UNITED STATES PATENT AND TRADEMARK OFFICE

APPLICATION NO.	FILING DATE	FIRST NAMED INVENTOR	ATTORNEY DOCKET NO.	CONFIRMATION NO.
10/756,906	01/14/2004	Chris Andre Du Plessis	10908/8 (MAJR)	3086
757	7590	12/09/2004	EXAMINER	
BRINKS HOFER GILSON & LIONE P.O. BOX 10395 CHICAGO, IL 60610			ANDREWS, MELVYN J	
			ART UNIT	PAPER NUMBER
			1742	
DATE MAILED: 12/09/2004

Office Action Summary

2/2

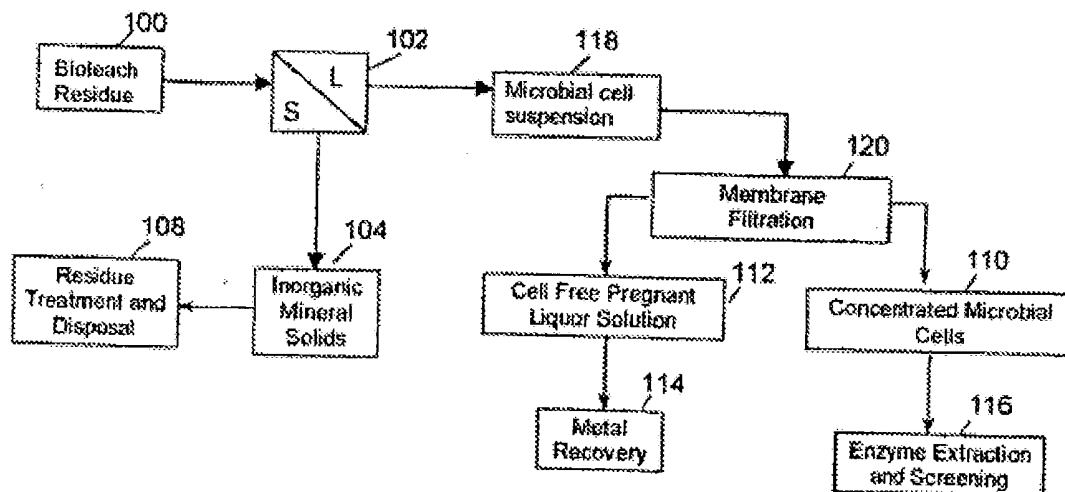
Claims 1-12 are rejected under 35 U.S.C. 103(a) as being unpatentable over publication WO 02/42504. The '504 publication discloses a method of producing bioproducts by a method of separating and recovering bioproducts from a slurry (see Claim 1 page 19) and Figure 2 shows in more detail a specific method for the separation of biomass (microbial cells) from minerals, solid particles and liquid solution and concentration of the microbial cell biomass from the rest of the bioleach liquor . In a second phase the microbial cell-containing supernat reports to a membrane filtration process (120) which results in a high microbial cell concentration solution 110 which facilitates the

down stream use of microbial cell biomass for enzyme extraction and screening(116) (seepage 15, line 21 to page16, line11) , optionally followed by recycling to a bioleaching reactor and as shown in Fig 2

but does not disclose backflusing or washing the screening (116) but these techniques are conventional.

Fig. 4

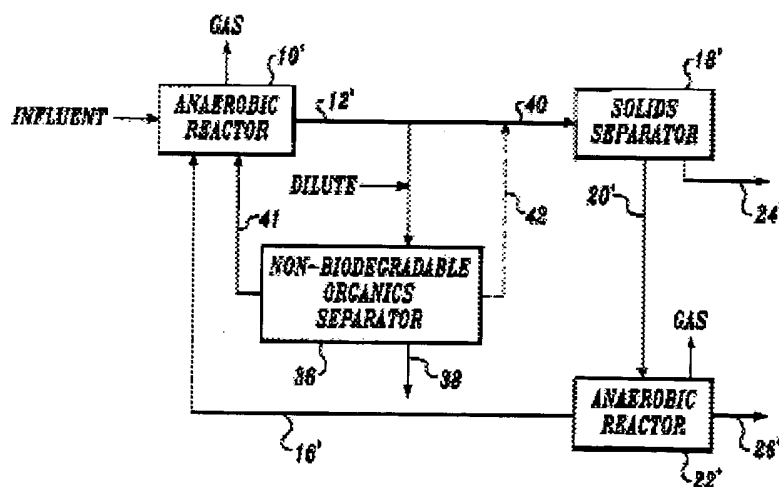
Claims 1 –12 are rejected under 35 U.S.C. 103(a) as being unpatentable over Burke (US 6,309,547). Burke disclose a method of improving the efficiency of an anaerobic treatment process wherein anaerobic bacteria are contacted with dissolved inorganic material and undissolved inorganic material followed by separation of a portion of the anaerobic bacteria and by delivering the separated anaerobic bacteria to a second reactor (col.9, Claim 8, as shown Fig 4) using any separation device for example screens, filters, cyclones and hydrocyclones (col.9, Claims 10 and 11)

Burke does not explicitly disclose back flushing or washing a membrane but these techniques are conventional.
